Inventor: VOELKER, Sunshine et al.

Serial No.: 10/623,923

**Remarks**

FIG. 4

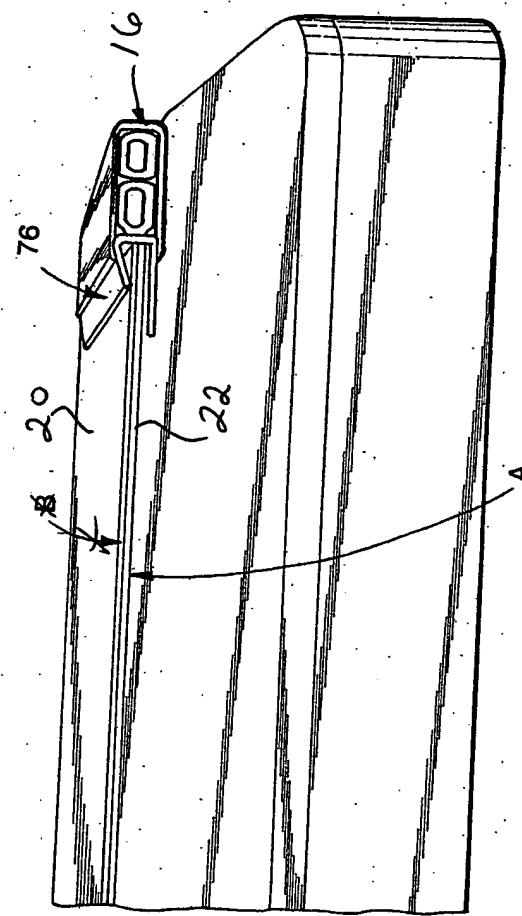
In the above identified Office Action, the Examiner raised several objections to the Drawings. Attached hereto are Replacement Sheets for some of the Figures and at the end hereof is an Appendix containing the proposed changes in red, with these sheets being marked with the legend "Annotated Marked-up Drawings". Approval of the changes is respectfully requested.
